**Re: FortisBC Inc. ("FBC") Certificate of Public Convenience and Necessity Application  
for the Grand Forks Terminal Station Reliability Project ~ Project No. 1598987 (the  
"Application")**

**FINAL SUBMISSIONS**

**FortisBC Inc. Certificate of Public Convenience and Necessity Application for the Grand  
Forks Terminal Station Reliability Project  
Project No. 1598987**

Figure 6 – Risk of Failure Compared to a Transmission Utility

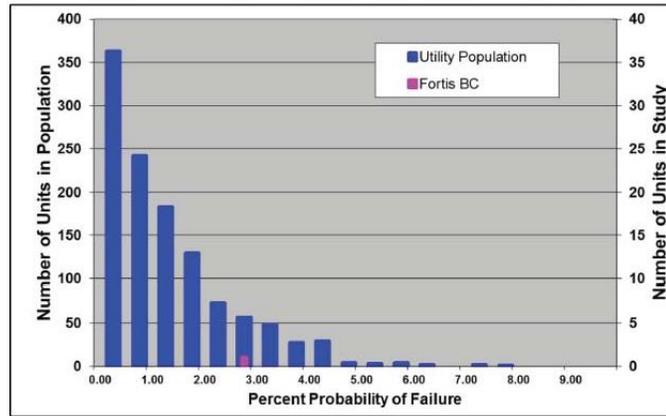
17. FBC considers the risk of failure (“**RoF**”) for the GFT T1 to be 2.6%.<sup>15</sup> This is on the high side compared with a typical utility population<sup>16</sup>, and FBC expects this to increase to approximately 3.5% over 30 years.

19. FBC considers that an acceptable risk of failure for a transmission station should be no higher than 2% based on industry standards<sup>20</sup> but does not expect the transformer will fail in the near term.<sup>21</sup>
20. FBC based their RoF of 2.6% on an ABB report filed in Appendix B in the application.
21. The ABB report provided the following table for the RoF. The 2.6% RoF was calculated based on the existing presence of C2H2 in oil and assuming no inhibitor in oil.

27. The CEC submits that it would not be unreasonable to discount the RoF to between 1% and 2%, which recognizes ABB's speculative RoF of 0.524% and FBC's experience replacing certain equipment as well as recognizing FBC's concerns regarding uncertainty.

28. Such a determination would place the RoF below FBC's threshold of acceptability of 2%.
29. The CEC notes that there are other additional areas of concern.

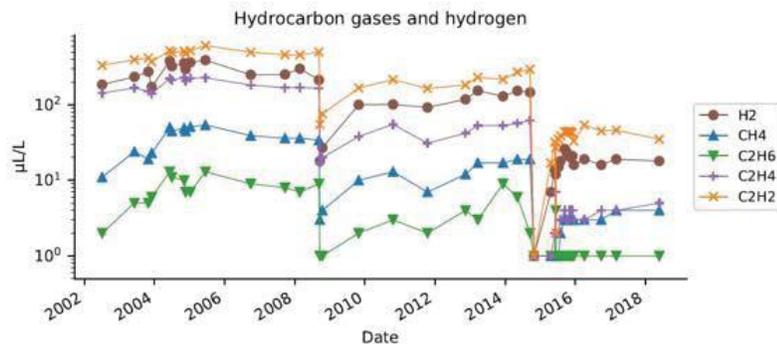
22. ABB speculated in the report that ‘the C<sub>2</sub>H<sub>2</sub> in oil is the result of oil leaking from the Load Tap Changer (“LTC”) and not an active arcing issue in the active part and probably there is still some inhibitor in the oil’. They also calculated the RoF at this condition, as well as for a new transformer. These results show RoF of 0.524% and 0.262% respectively.<sup>23</sup>
23. Additionally, FBC assumes that GFT T1 Dissolved Gas Signature and unit health will be relatively stable as long as the load tap changer operation is not required.<sup>24</sup>
24. FBC states that they selected the worst case scenario for the RoF because:

“GFT T1 has had high acetylene (C<sub>2</sub>H<sub>2</sub>) levels since 2002 as shown in the figure below. FBC replaced the diverter tank-barrier board to try and address this issue. However, replacing this equipment did not lower the acetylene levels. FBC has operated the GFT T1 load tap changer in manual control since April 2016, which appears to have resulted in stable dissolved hydrocarbon and hydrogen gases. However, the load tap changer may not be the actual cause of the high acetylene levels. Therefore, FBC selected the worst case scenario for the risk of failure (RoF) as 2.6 percent.”

25. FBC also states that:
- “Since the likely cause of the abnormal fault gases has not been determined and given the fact that GFT T1 is now 53 years old, exceeding the expected transformer lifespan of 40 years, FBC considered the risk of failure of 2.6 percent calculated by ABB to be appropriate.”<sup>26</sup>
26. The CEC is of the view that a 2.6% RoF is likely high given FBC’s acknowledgement that there is uncertainty surrounding the reason for the fault gases, there appears to be evidence that operating the load tap changer in manual has stabilized the situation, and ABB’s speculation as to its potential source.

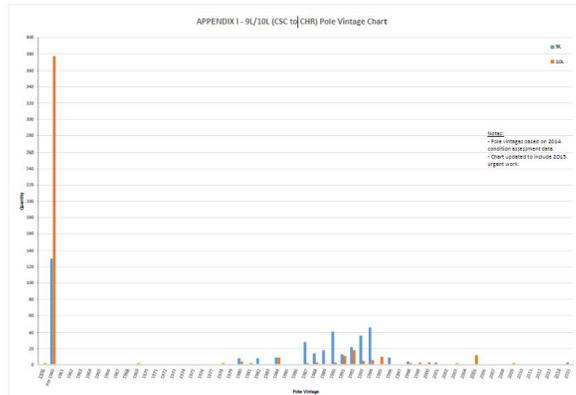
34. FBC de-energized 10L in 2010 because it is in poor condition and was creating an operational challenge.<sup>35</sup>
35. There are a large number of poles on 9L and 10L between CHR and CSC that are well beyond their average life expectancy, which is up to 46 years with stubbing.<sup>36</sup> FBC provides a Pole Vintage chart in BCUC 1.1.1 which demonstrates this fact.
